**CULTURAL RESOURCES OFFICE
PRESERVATION BOARD
REGULAR MEETING
MONDAY – AUGUST 24, 2015 — 4:00 P.M.
1520 MARKET ST. #2000
ST. LOUIS, MO. 63103
www.stlouis-mo.gov/cultural-resources**

DATE: August 24, 2015
ADDRESSES: 6322 S. Grand Boulevard
ITEM: Demolition of the Southern Funeral Home and construction of a new building in conjunction with the rehabilitation of the Parkview at 6336-40 S. Grand.
JURISDICTION: Preservation Review District; — Ward 11
STAFF: Betsy Bradley, Cultural Resources Office

DATE: August 24, 2015
ADDRESSES: Kiener Plaza, bounded by Market, Chestnut and N. 7th Streets and N. Broadway
ITEM: Review of proposed new design
JURISDICTION: Ordinance #64689 review of City Parks and Ordinance #69954 regarding Kiener Plaza — Ward 7
STAFF: Betsy Bradley, Cultural Resources Office

DATE: August 24, 2015
ADDRESS: 1909 Lafayette Avenue
ITEM: Preliminary Review: New construction, single-family house
JURISDICTION: Lafayette Square Certified Local Historic District — Ward 7
STAFF: Jan Cameron, Cultural Resources Office

PROPOSED PLAN FOR PLAZA

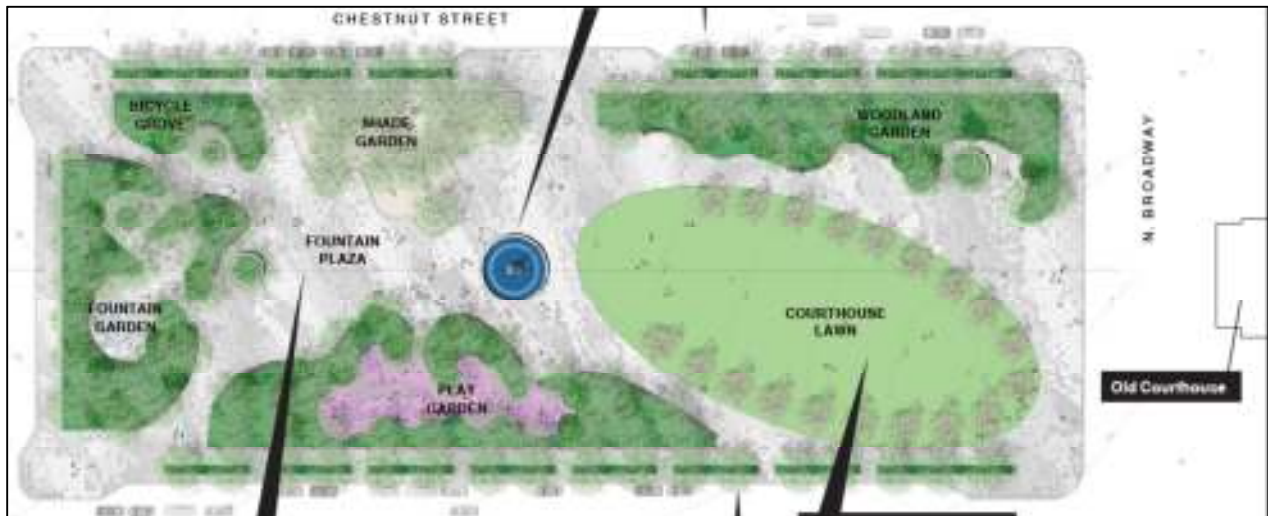
- The plan proposes a prominent "Courthouse Lawn" on the eastern portion of the plaza, opposite the Old Courthouse. The plan places the lawn oriented to the southeast corner of the plaza rather than on the prominent east-west axis the design acknowledges and that is so firmly reinforced by the Old Courthouse.

- The view of the Old Courthouse is not protected with a full, on-axis view due to the proposed low trees at the edges of the Courthouse Lawn.
- The orientation of the lawn on axis would further a somewhat formal, civic component of the design, which in other areas provides decidedly informal components related to everyday use.

- The design for the Courthouse Lawn does not highlight the dominant east-west axis for the Gateway Mall and nor support as much as it could the plaza's role as the "front door" to the Jefferson National Expansion Memorial complex; as planned, Kiener Plaza would exist beside the Memorial complex, it but without having a strong relationship to it.

- The re-orientation of the lawn on axis and affording more open views of the Old Courthouse with a revised planting plan would provide some civic feeling and association for the public plaza, as well as provide a transition from the formality of the Old Courthouse to the more informal portions of the plaza.

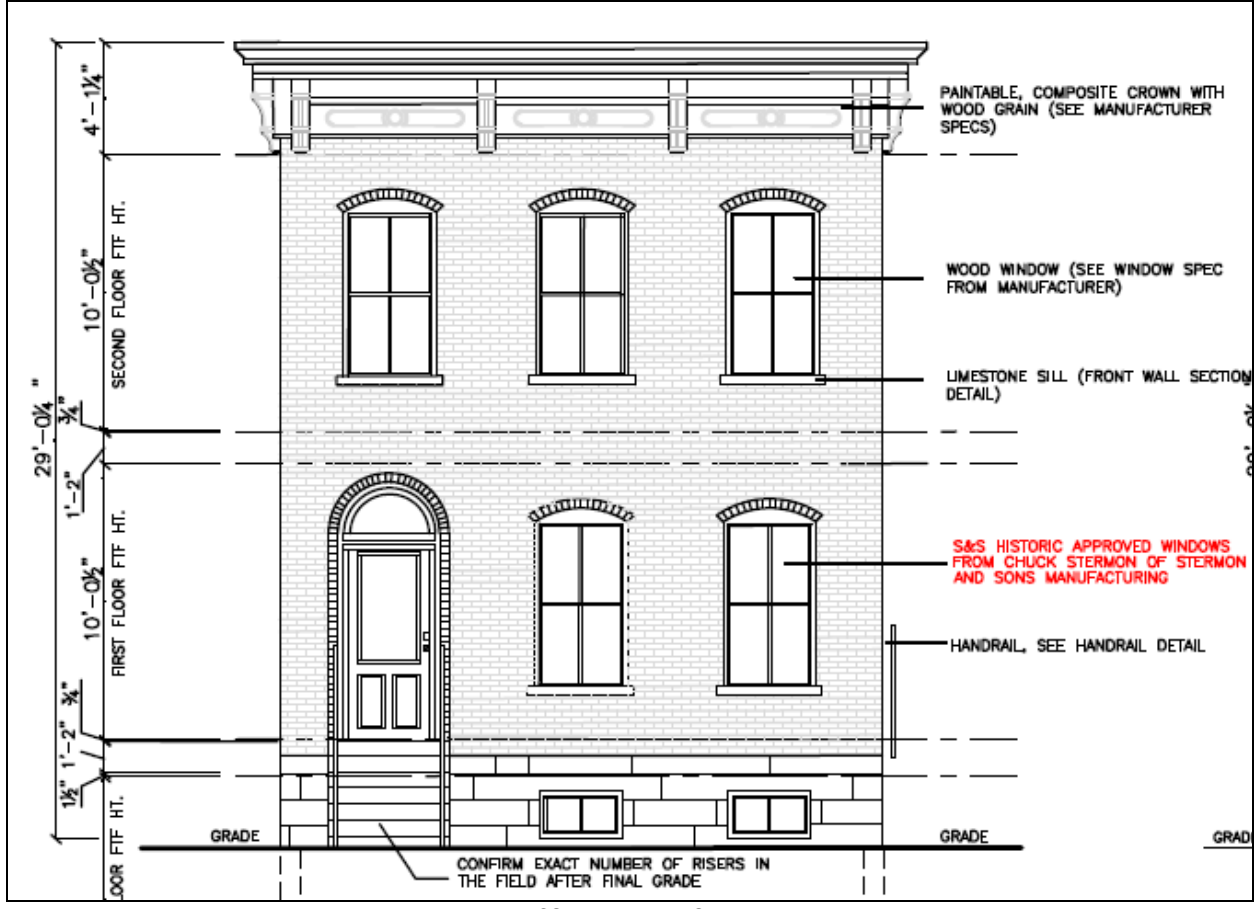
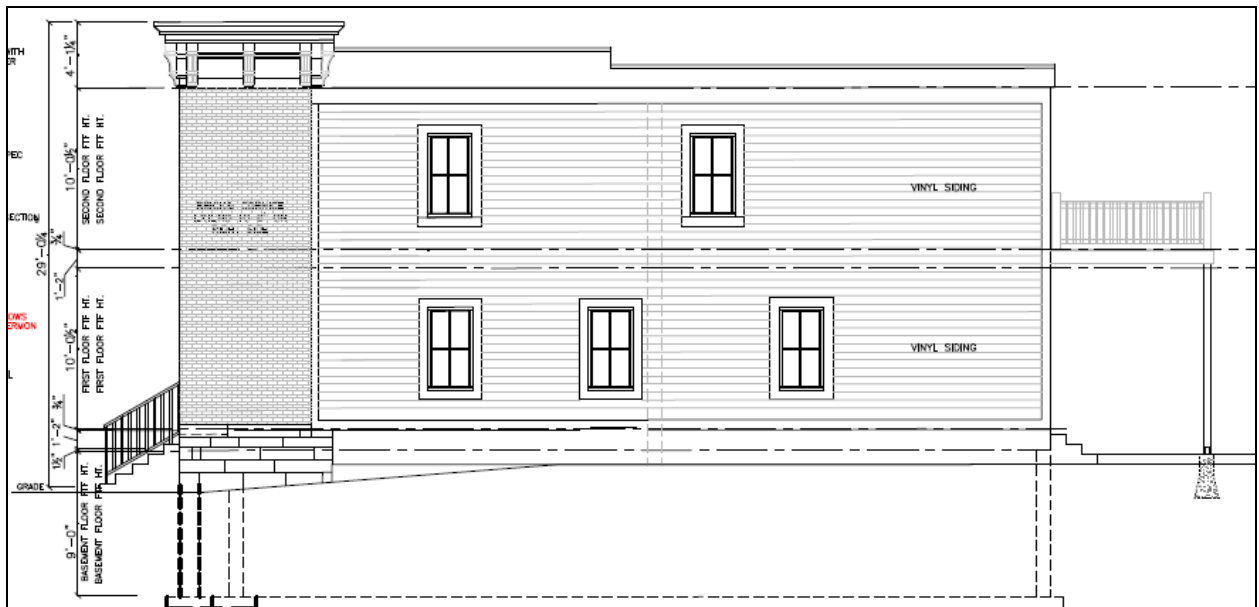
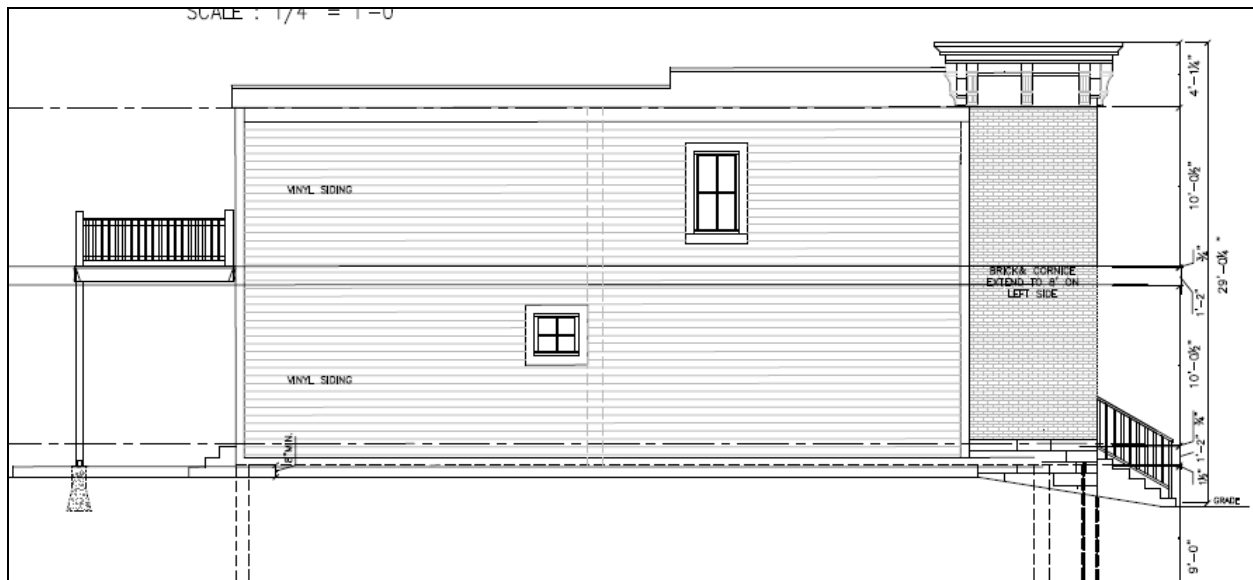
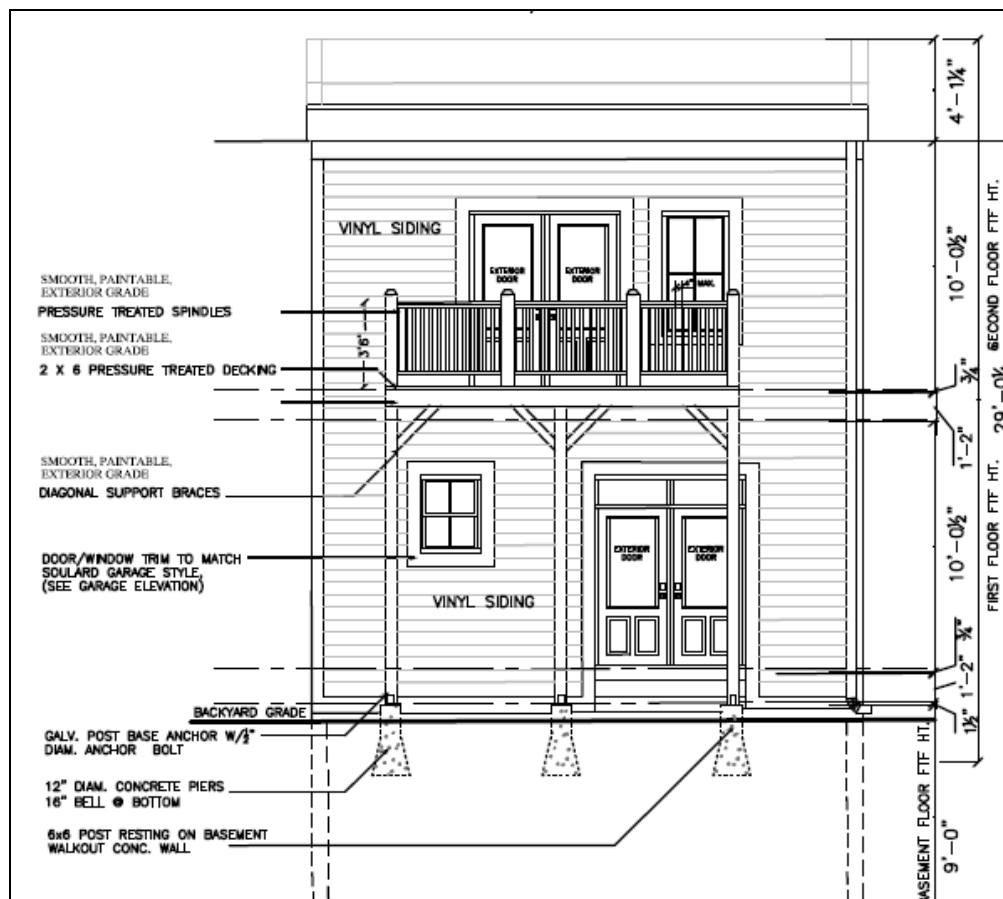
- The proposed site for the new construction is located in the Benton Park Local Historic District.
- The proposed design complies with all requirements for new construction in the Benton Park Historic District Standards.
- Final material choices have not been made, but the applicant intends to comply with the requirements of the Historic District Standards.

Based on these Preliminary findings, the Cultural Resources Office recommends that the Preservation Board approve the new application, with the stipulation that final plans and materials will be reviewed and approved by the Cultural Resources Office.
